**DRAFT PACIFIC FISHERY MANAGEMENT COUNCIL (COUNCIL) COMMENT
LETTER ON DRAFT OREGON WIND ENERGY AREAS**

Re: Bureau of Ocean Energy Management Request for Comments: *Draft Wind Energy Areas - Commercial Leasing for Wind Power Development on the Oregon Outer Continental Shelf (OCS)*

Figure 3: Draft WEA A (Coos Bay) aliquots recommended for potential removal to minimize impacts to fishing activities.

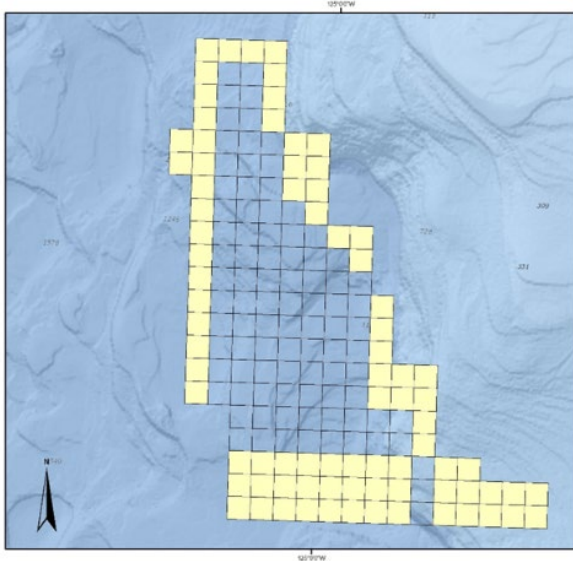
Based on Council concerns about impacts to these fisheries, we recommend that BOEM consider removing specific areas from the Draft WEAs. Figure 1 and Figure 2 below display the composite ranked importance data layers for several fisheries in Draft WEA A (Coos Bay) and Draft WEA B (Brookings), respectively. Figure 3 and Figure 4 display the BOEM aliquots in Draft WEAs A and B respectively, that should be considered for removal, based on the importance to specific commercial or recreational fisheries or sectors. Detailed explanations and a list of aliquot numbers are found in the Fisheries section below. The Council is willing to assist BOEM in further refining the Draft WEAs.

Figure 6: Sensitive habitats within Draft WEA A (Coos Bay), and aliquots proposed for removal (bold outline).

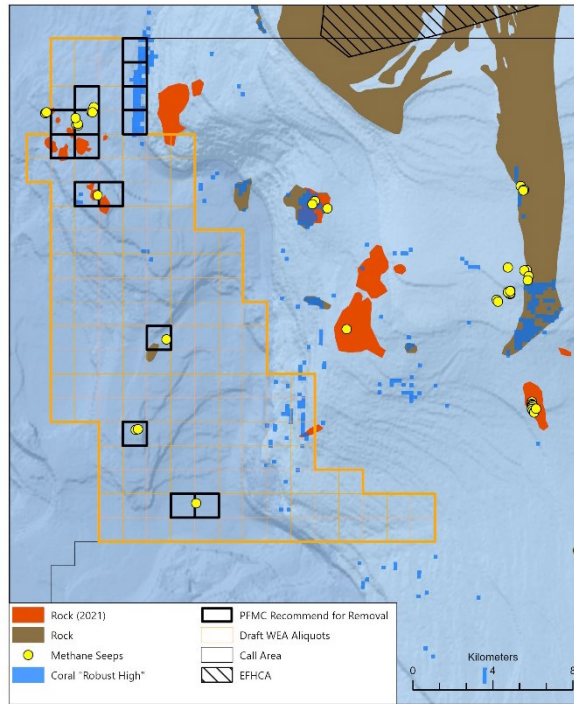
Significant sensitive habitat resources occur in both Draft WEAs A and B (Figure 5 and Figure 6, respectively), and/or in the surrounding areas. These habitat resources include:

Within the Draft WEAs, the Council recommends avoiding areas with sensitive benthic habitat resources by removing aliquots that have substantial overlap with these resources and implementing a minimum 500 m buffer around the resources to prevent disturbance or damage from site assessment, installation, operations activities associated with wind projects and cable routes.

Figure 7: Ranked importance of albacore charter fishing in the area of the Coos Bay WEA (Draft WEA A).

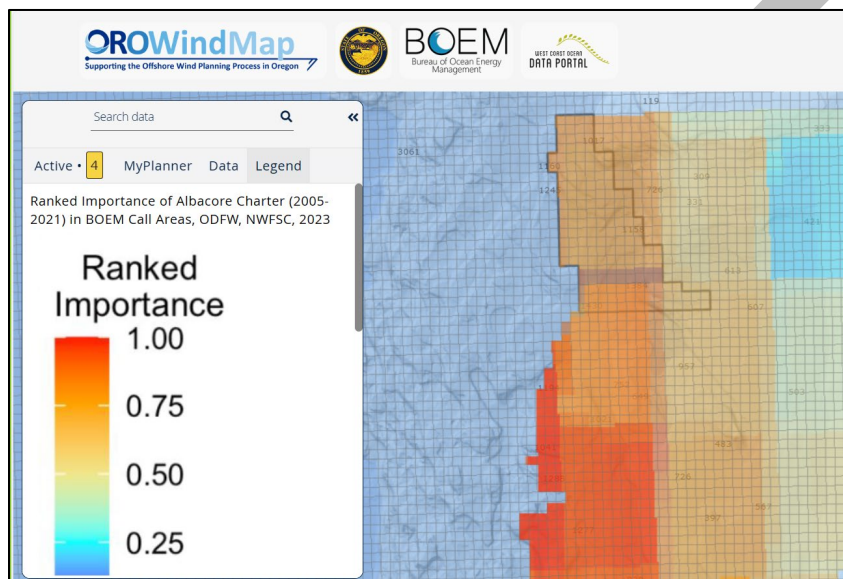
Areas still remain within both Draft WEAs that are important to the commercial and charter vessel albacore fisheries. The combined fisheries data layer had the effect of diluting the dependence of the albacore fleet(s) on those areas.

Figure 8: Ranked importance of albacore charter fishing in the area of the Brookings Draft WEA.

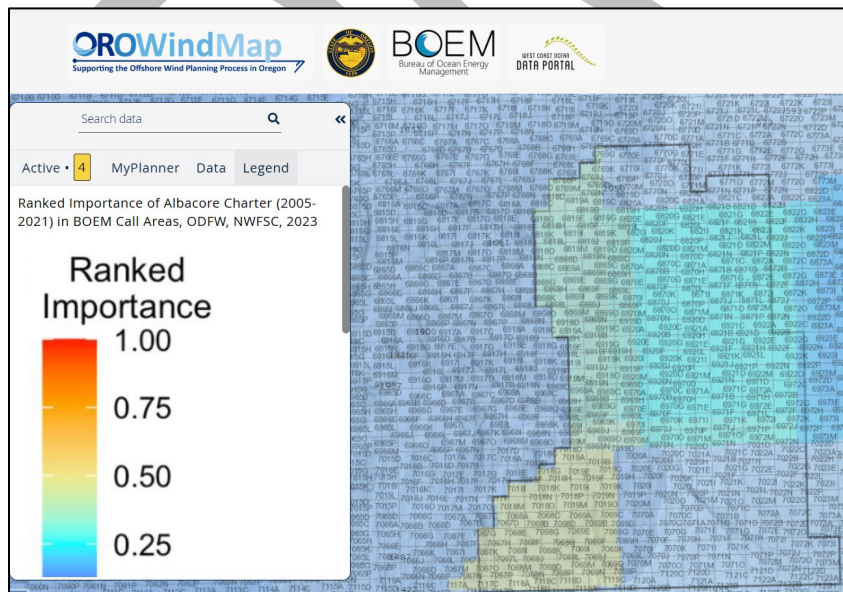
While some areas within the Brookings Draft WEA may appear to be of lower importance (i.e., having a ranked importance less than 0.5) to Oregon's albacore fisheries, these areas are highly important to commercial and recreational fisheries based in southern Oregon and northern California. Those areas should be considered for removal.

Figure 9: Groundfish bottom longline fishing effort using ODFW and NWFSC ranked fisheries data. OROWindMap link: <https://bit.ly/3PyPfU5>. (left: Draft WEA A; right: Draft WEA B).

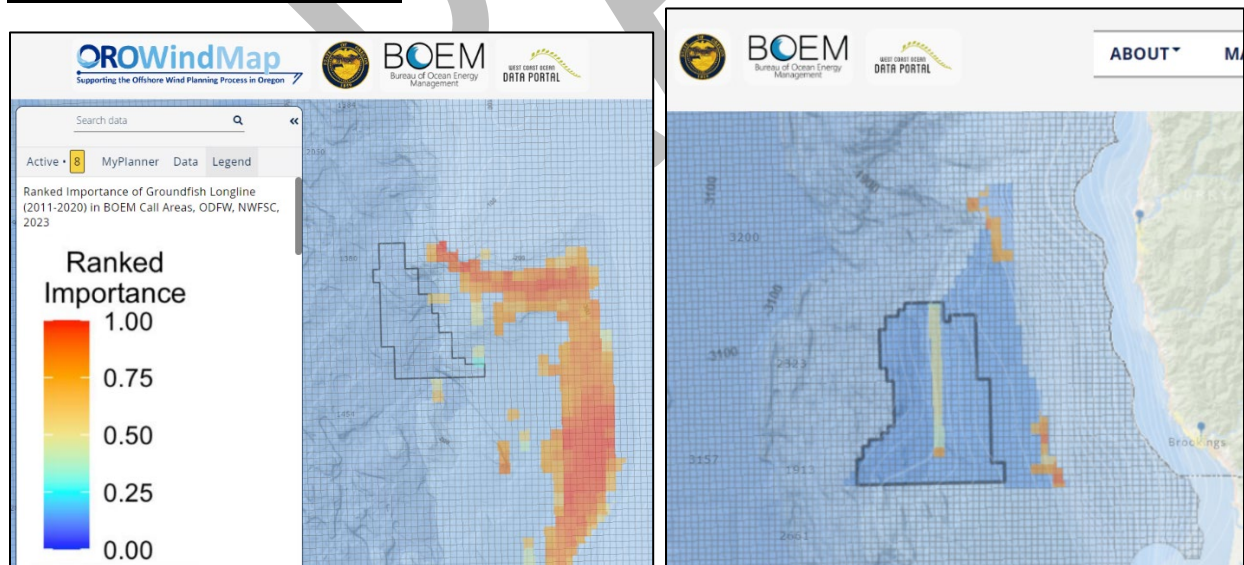
There is fishing activity in the center of the Brookings Draft WEA B, concentrated in a north-south line. Removing these areas from the Draft WEA would allow longliners to set along the fathom curve or seafloor feature that has historically been fished. Additionally, removing the eight aliquots below that center channel would create a travel-through/transit area for fishermen that would alleviate the need to make the return trip to the northern end to exit the WEA (See Figure 17 and Figure 18). This continuous transit opportunity would create efficiencies for longliners and would increase safety for vessels and crews, especially those that operate in this area during the spring and summer when the prevailing wind is out of the northwest.

Figure 10: Groundfish pot ranked importance using ODFW and NWFSC ranked fisheries data. OROWindMap link: <https://bit.ly/3RB1OAT>. (left: Draft WEA A; right: Draft WEA B).

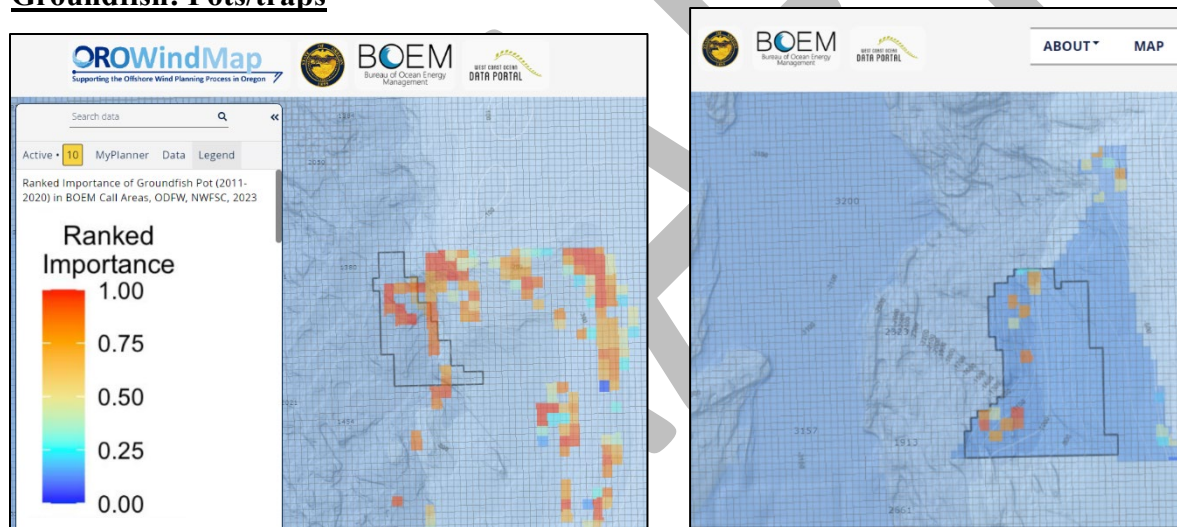
Seafloor features and bathymetry largely account for the changes in fishing behavior between longlines and pot/trap fishing. Based on this rationale, **BOEM should consider removing specific aliquots from the Draft WEAs** (see Figure 17 and Figure 18).

Figure 11: Groundfish bottom trawl ranked importance using ODFW and NWFSC ranked fisheries data. OROWindMap link: <https://bit.ly/3PINiEW>. (left: Draft WEA A; right: Draft WEA B).

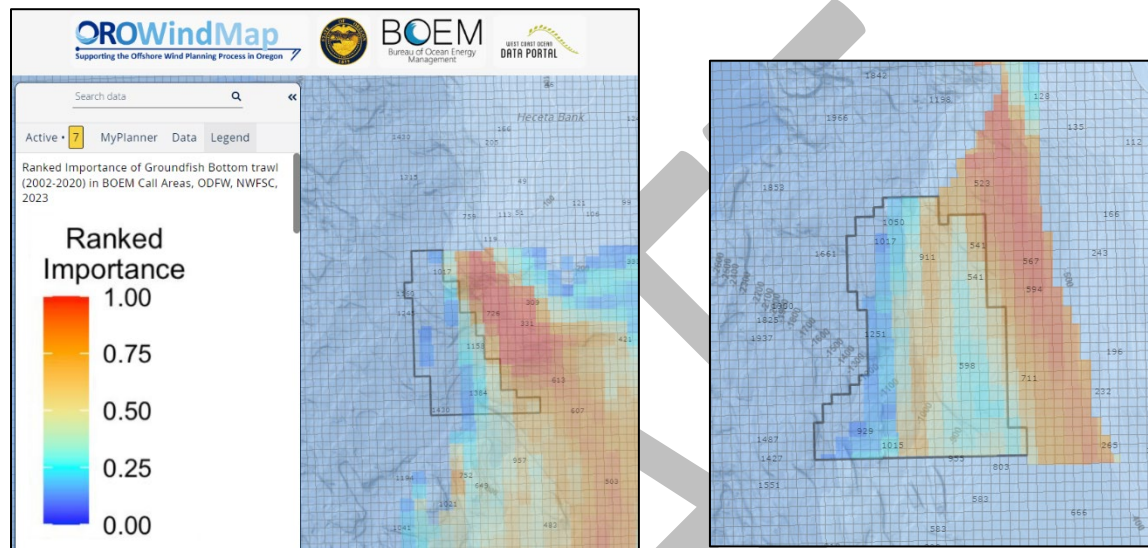
It is clear from Figure 11 that trawlers also utilize a similar corridor in the middle of the Brookings Draft WEA that bottom longliners do. In the same fashion, removing the aliquots in that corridor would enable trawlers to access a traditional fishing area that has historically been important and may become critically important in the future. Removing the aliquots in the actively fished area will create a “travel-through” or transit zone so vessels would not have to enter from the north, fish all the way down the corridor, then return north to exit the WEA. The same reasons that applied to bottom longline fishing apply here: greater operational efficiency; increased safety, especially

Figure 12: Shoreside hake fishing ranked importance using ODFW and NWFS ranked fisheries data. OROWindMap link: <https://bit.ly/3ZCi1HX>. (left: Draft WEA A; right: Draft WEA B).

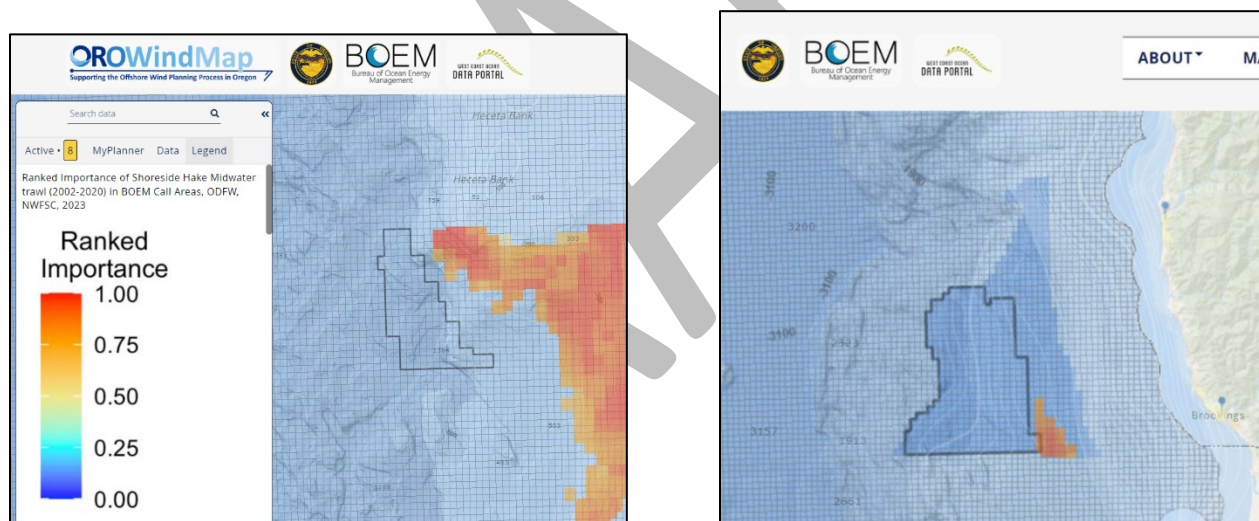
Shoreside whiting fishing vessels also require large areas for turning around and maneuvering around aliquot corners or seafloor features, such as the southeast corner of the Brookings Draft WEA. Removing important areas from the Draft WEAs will afford these vessels the opportunity to retain their operating efficiency and flexibility while remaining safe at sea. See Figure 17 and Figure 18.

Figure 13: At-sea mothership sector intensity, 2011-2015, using NWFSC FRAM data. OROWindMap link: <https://bit.ly/3LI6OAa>. (Left: Draft WEA A; right: Draft WEA B).

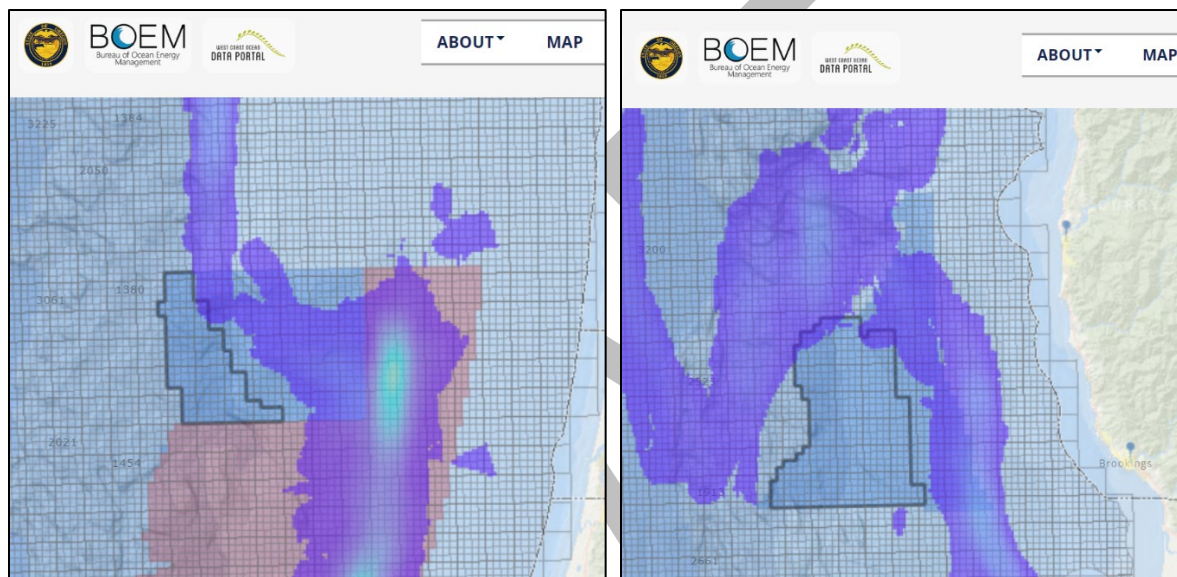
Figure 13 shows mothership activity within the Draft WEAs in the 2011-2015 time frame. The fishing intensity during this time period provides a better indication of the importance of areas within and near the two Draft WEAs, because the fishing locations of the mothership sector are quite variable between years. Nonetheless, in certain time frames, the areas in and around the

Draft WEAs are very important and very productive. In many years, it is impossible to predict which areas or portions of the Draft WEAs will be important in the future as stocks change and the ocean changes. As noted under “General Comments and Suggestions,” removal of aliquots shallower than 400 fathoms would help the catcher vessels participating in the mothership sector, since most of their target species, hake, is caught in those areas.

Referencing these figures, specific areas should be considered for removal in order for the mothership sector to retain historical opportunities for fishing. See Figure 17 and Figure 18.

Figure 14: At-sea catcher-processor intensity, 2011-2015, using NWFSC FRAM data. OROWindMap link: <https://bit.ly/3LBF93y>. (Left: Draft WEA A; right: Draft WEA B).

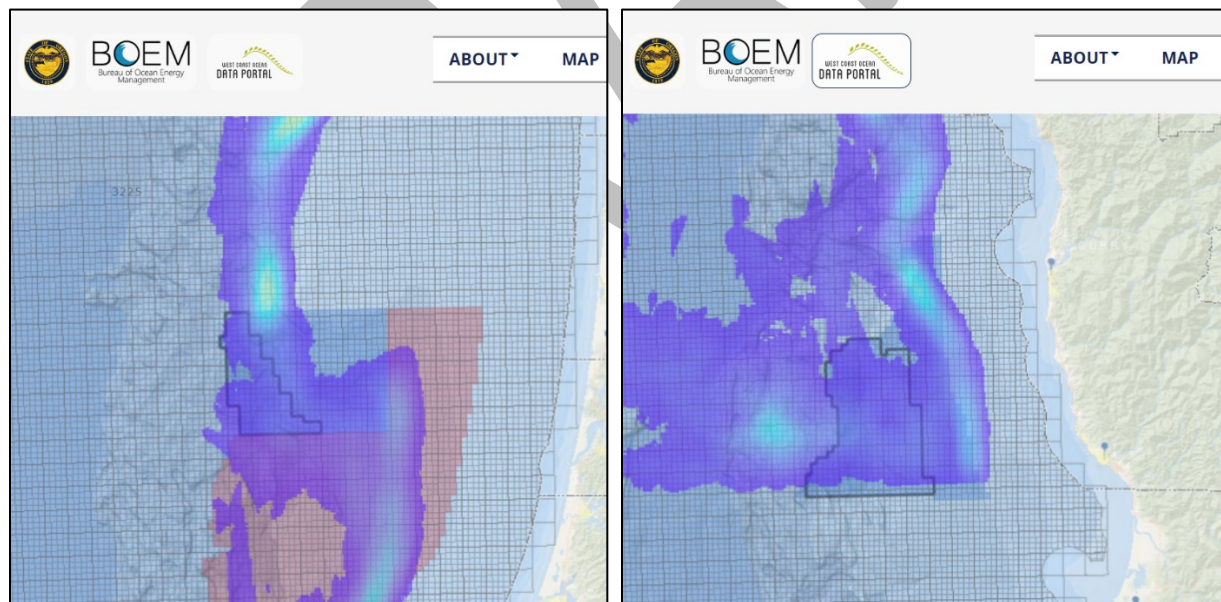
The above figures show the years during which the CP sector frequented both draft WEAs. According to the rest of the dates in the NWFSC FRAM dataset, the CPs did not frequent the areas outside of the 2011-2015 time frame. This area is important for several reasons: Target species may be move into these areas for reasons relating to temporary or permanent ocean changes; or species caught as bycatch may move *out* of these areas during ocean changes while the target species, hake, is in relative abundance. That is, the areas may be important for bycatch avoidance.

As changes in the ocean occur and another strong El Nino appears to be forming, these areas may once again be important to the CP sector. Therefore, we suggest removing several areas that are adjacent to productive fishing grounds to maintain vessels’ maneuverability and to allow for flexibility in harvesting operations into the future. See Figure 17 and Figure 18.

Figure 15: ODFW recreational bottomfishing trips by reef, 2015-2020. OROWindMap link: <https://bit.ly/3LF9cHM>. (Left: Draft WEA A; right: Draft WEA B).

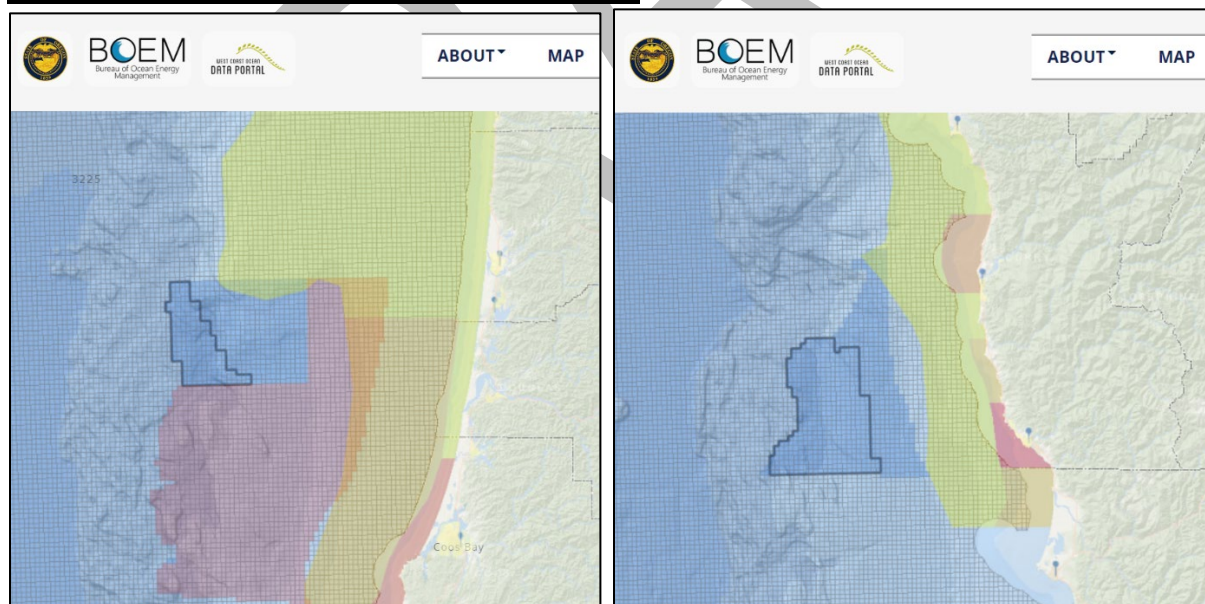
Both private and charter vessels target rockfish and other species, but the maps above show the primary recreational effort is closer to shore and well shoreward of the Draft WEAs. However, as restrictions around rockfish, salmon or halibut increase, sport fishermen will seek other species to target. For example, deepwater lingcod, Pacific halibut and offshore rockfish. Currently, sport fishermen in Oregon are looking for additional opportunity to pursue recreational fishing for sablefish. Both private and charter fishermen will likely fish farther offshore and in many of the same areas as the sablefish longliners and pot/trap fishermen. The paucity of datasets available complicates consideration of recreational effort within the Draft WEAs. Conducting outreach to recreational fisheries would better inform BOEM of potential impacts to and conflict with these economically important fisheries.

In order to minimize potential impacts to recreational bottomfish fisheries, the Council recommends BOEM conduct targeted outreach with representatives of these fisheries to fill data gaps to better inform potential final WEAs.

Figure 16: Draft Coos Bay WEA (A) in blue; Dover and petrale winter spawning areas in pink (Source: fishing industry input).

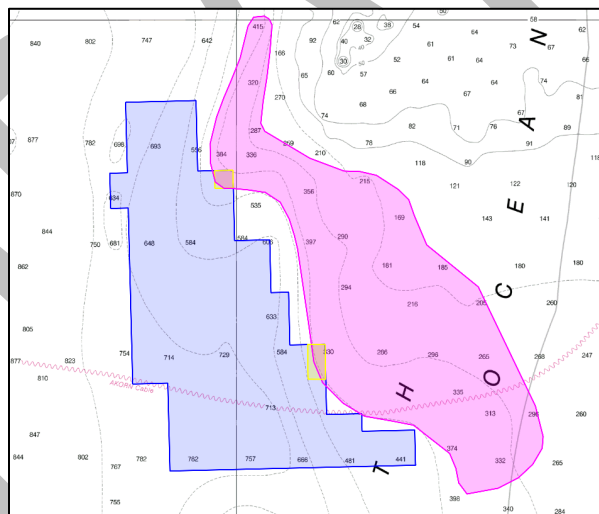
OROWindMap does not include the Dover and petrale sole spawning areas, but trawlers have identified the area in pink in Figure 16 as the primary area for these two stocks off the southern Oregon Coast. **The Council recommends that BOEM include these data and explore the inclusion of other ecosystem-based data layers for inclusion in the NCCOS suitability model.**

Figure 17: Composite of all aliquots recommended for removal from the Draft Coos Bay WEA, based on importance to fishing sectors managed by the Council.

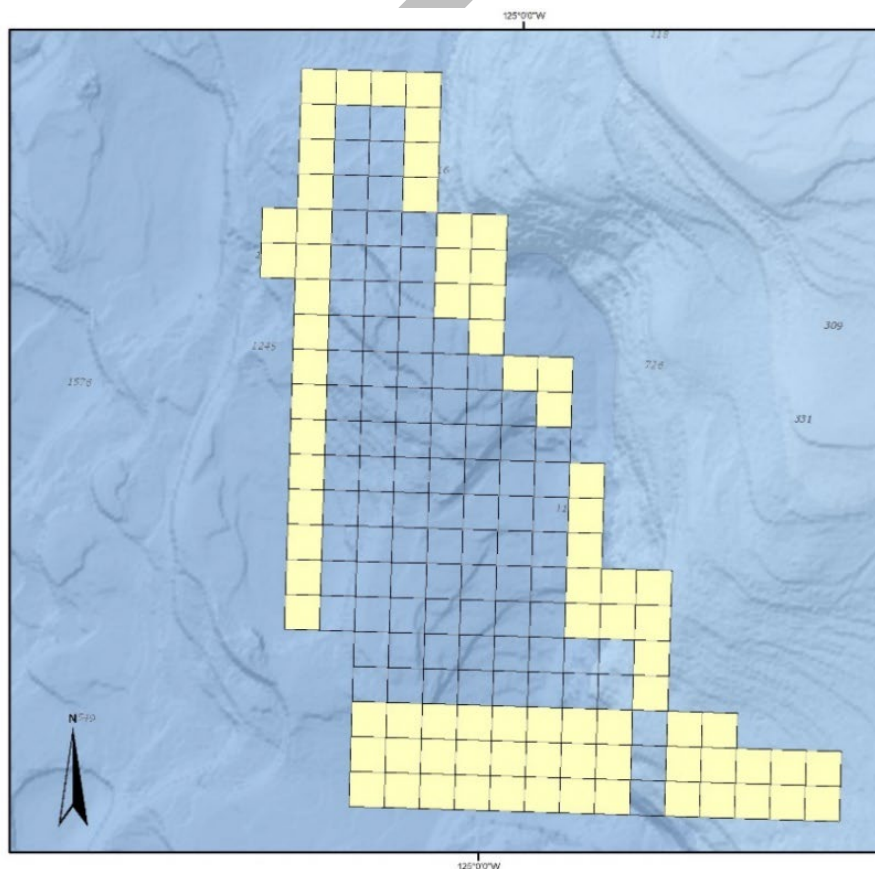
areas that are integral for fishing activities managed by the Council. **The Council recommends that BOEM remove the specific areas described below and collated in Figure 17 and Figure 18, given the economic and social importance of both commercial and recreational fisheries across all sectors to the state of Oregon and the U.S. West Coast.** These recommendations are based on the Oregon Department of Fish and Wildlife/National Marine Fisheries Service ranked suitability maps in the Draft Report and housed in the [OROWindMap tool](#), other maps as indicated, and input from subject matter experts in the fishing sectors described below.

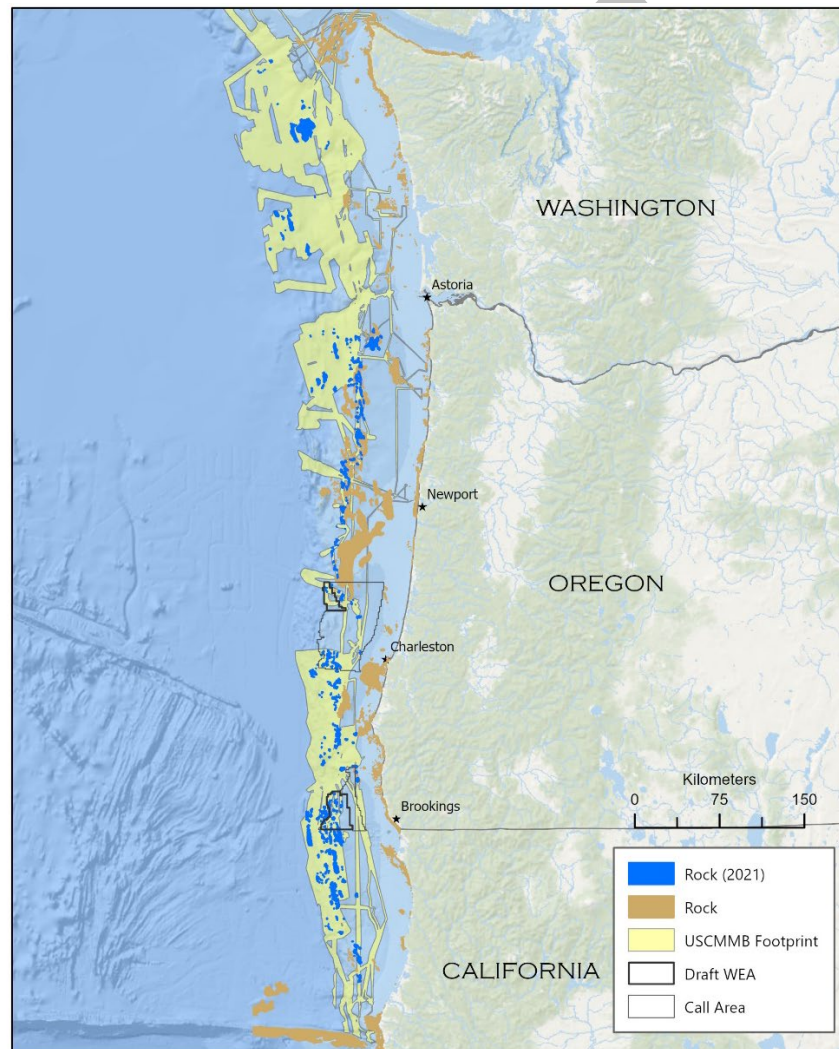
Mendocino Ridge). As with all rock, carbonate rock qualifies as rocky reef HAPC for groundfish. More than 1,000 sq. km. of carbonate rock was delineated within the USCMMB footprint, of which 100 sq km is in the two Oregon Call Areas and 41 sq km is in the two Draft WEAs (Figure 19). This data are available from Merle et al. (2021) upon request. This new habitat information stresses the importance of using all available high-resolution seafloor mapping data to identify sensitive habitats within the Draft WEAs and throughout the region that will be affected by wind energy projects and associated cable routes. To our knowledge, the CMECS-reclassified “SGH v.4” HAPC data layer (source: Goldfinger et al., 2014) was the only seafloor mapping data that informed BOEM’s decision on WEA siting.

The Council strongly recommends BOEM use recent (2016-2023) high-resolution mapping data to identify sensitive habitats not delineated in SGH v.4 (Goldfinger et al. 2014), particularly rocky reef HAPC, throughout the region that will be affected by wind energy projects and associated cable routes. The Council also recommends that BOEM put forth additional resources to ensure appropriate seafloor mapping and characterization happens in waters <200m prior to cable route planning.
